## PRODUCT/PROCESS CHANGE NOTICE (PCN)

PCN #: **TB1110-05**                      DATE: **12/07/2011**  
 Product Affected: **6 mm x 6 mm VFQFN-28**  
                           **6 mm x 6 mm VFQFN-40**  
                           **6 mm x 6 mm VFQFN-48**  
 Date Effective: **3/07/2012**

### ATTACHMENT I - PCN #: TB1110-05

#### New Shipping Tray - Top Tray

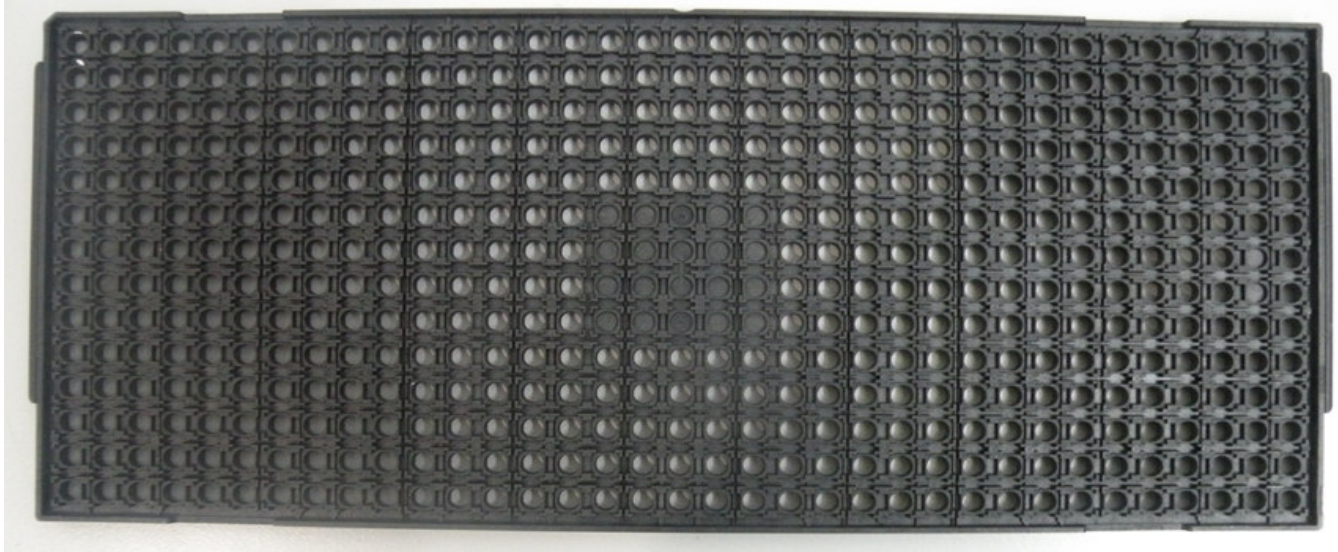
There will be changes in the tray dimensions and tray design where an additional hump has been included at each of the 4 corners of each tray pocket of the bottom of the tray. Refer to Table 1 for more details.

#### **New Shipping Tray - Bottom Tray**

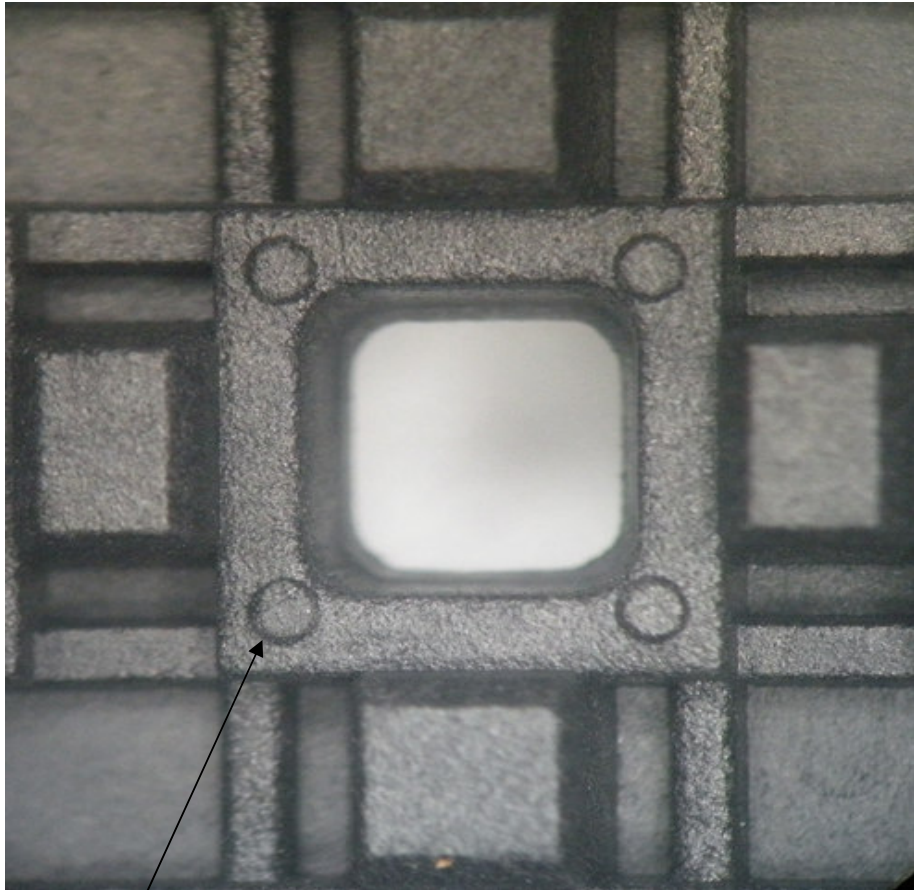
Hump at the four corners of each tray pocket  
which prevent IC stuck on the tray
